ADDENDUM NO. 2
TO THE
DRAWINGS AND PROJECT MANUAL
FOR
**2024 CY-CREEK HS RENOVATIONS
CYPRESS-FAIRBANKS ISD
CYPRESS, TEXAS**

02/06/2025

2.1 GENERAL

FS2.2

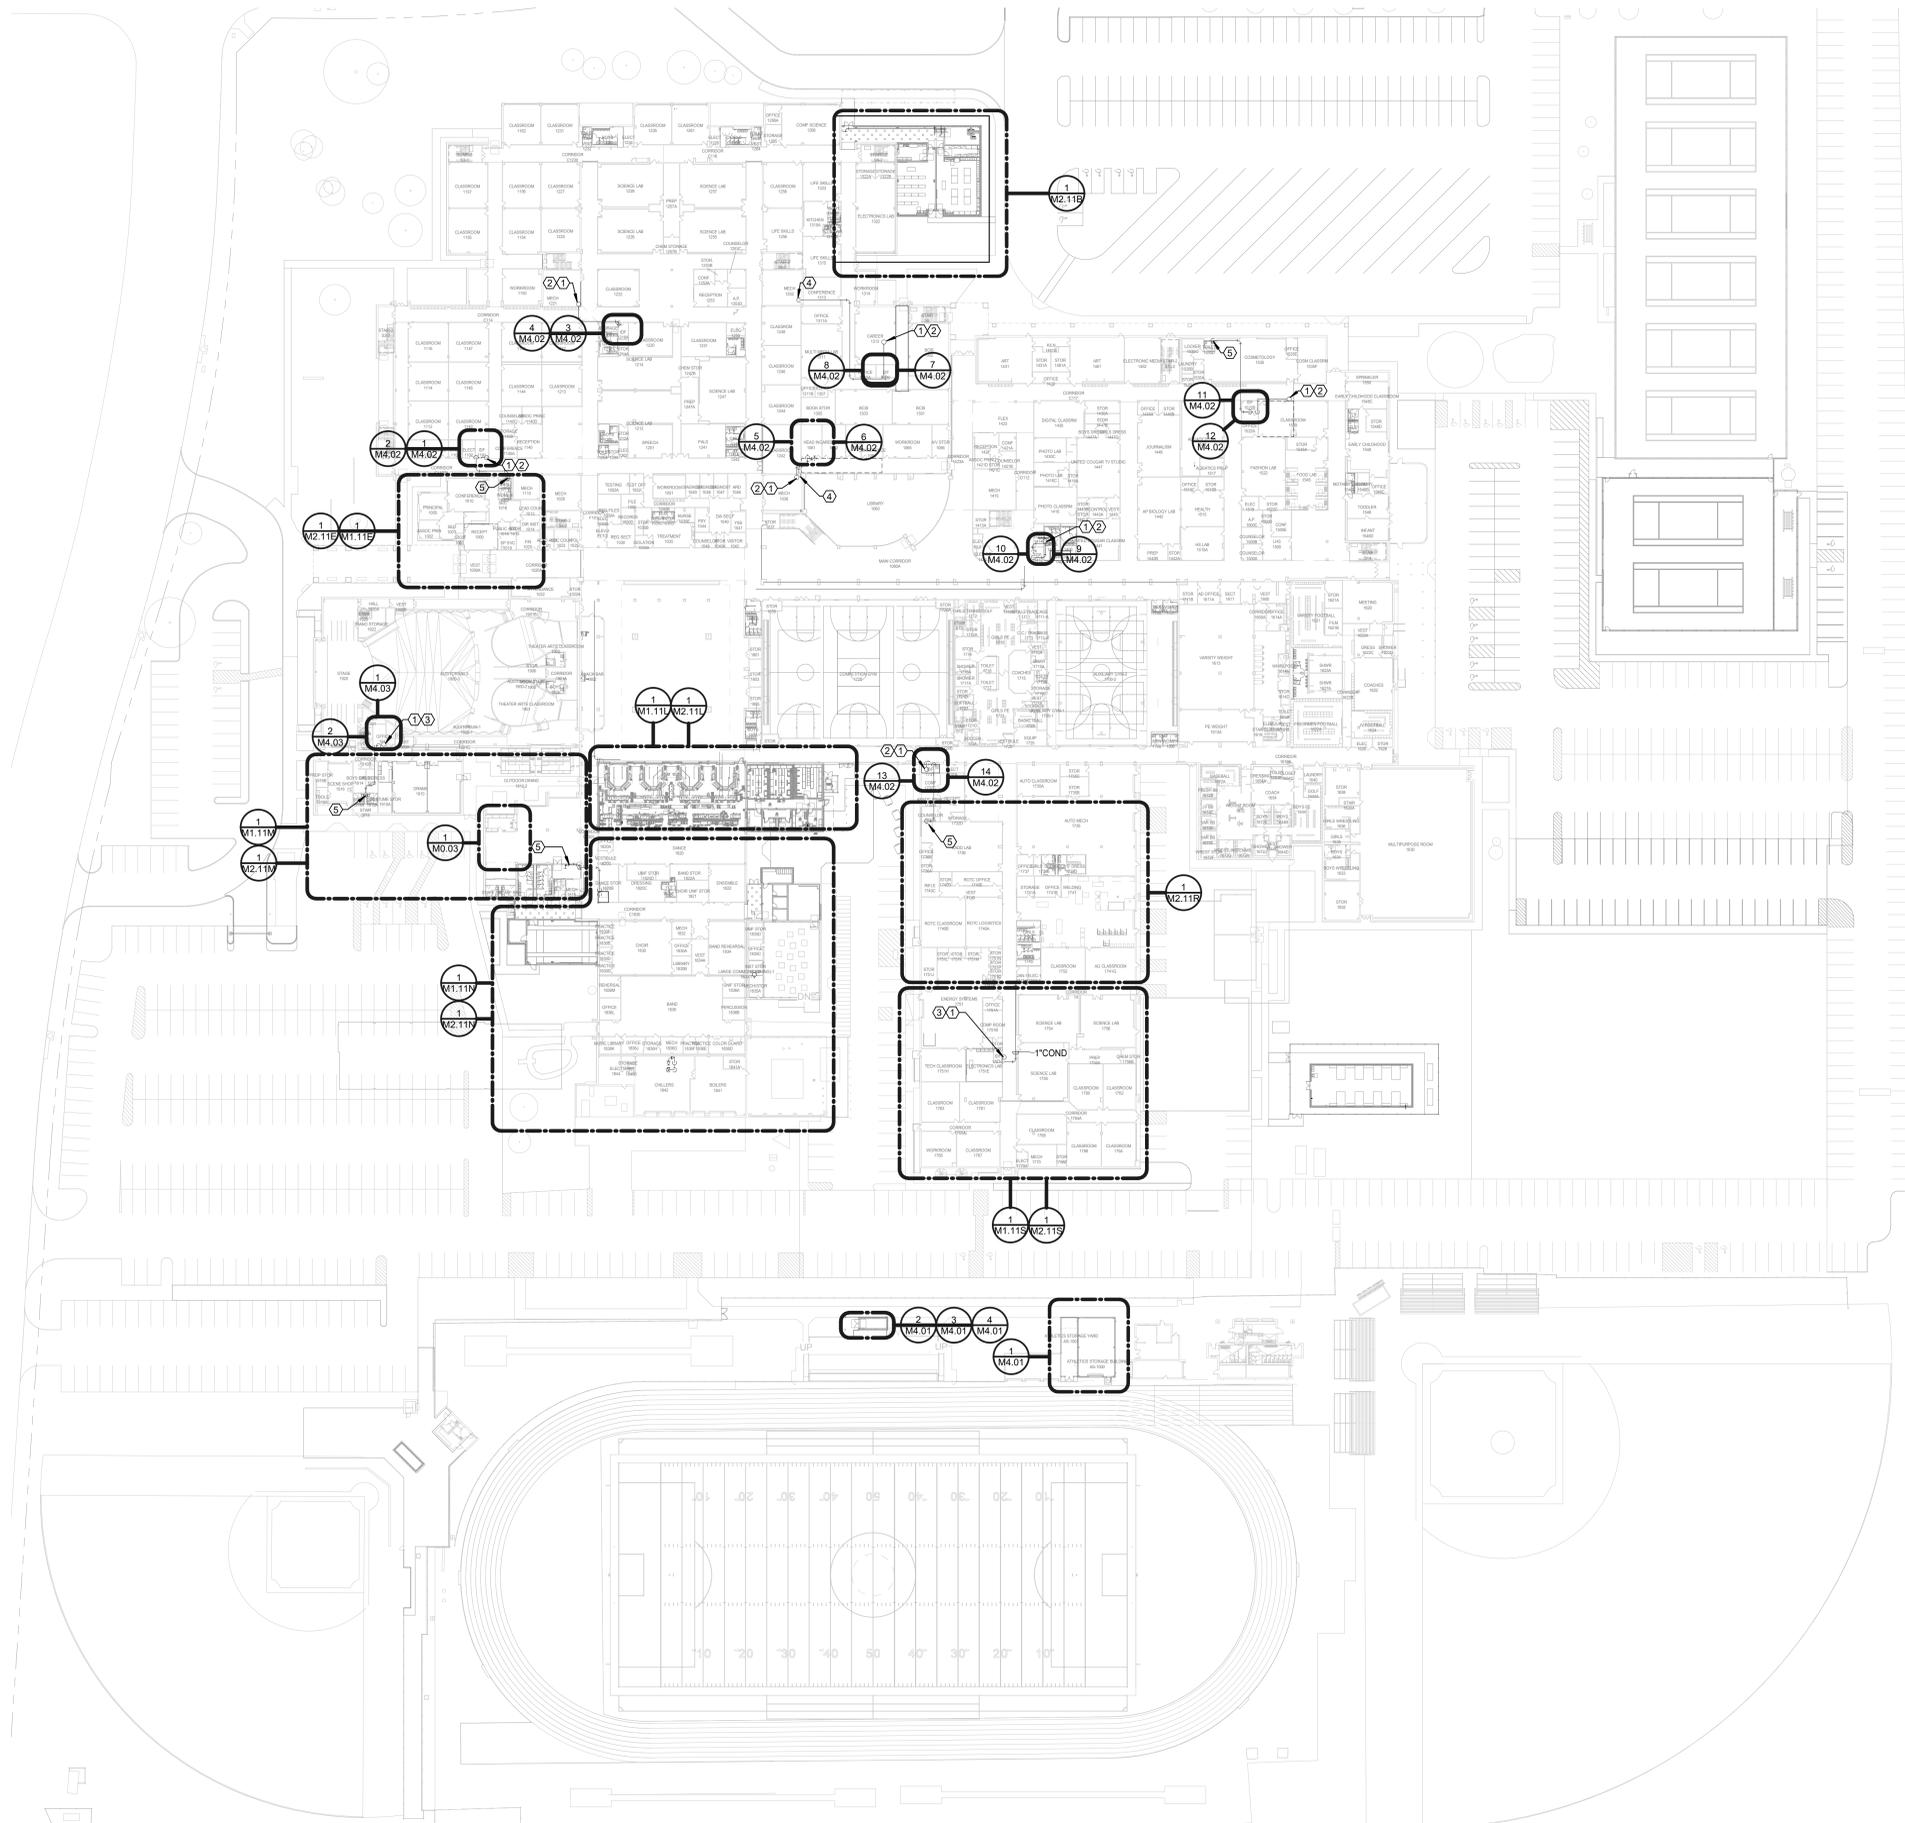
- 1) Sheet FS2.2 - FS TEMPORARY COLD STORAGE PLAN.
 - a) Incorporate items E102A and E102B into the electrical connections schedule.
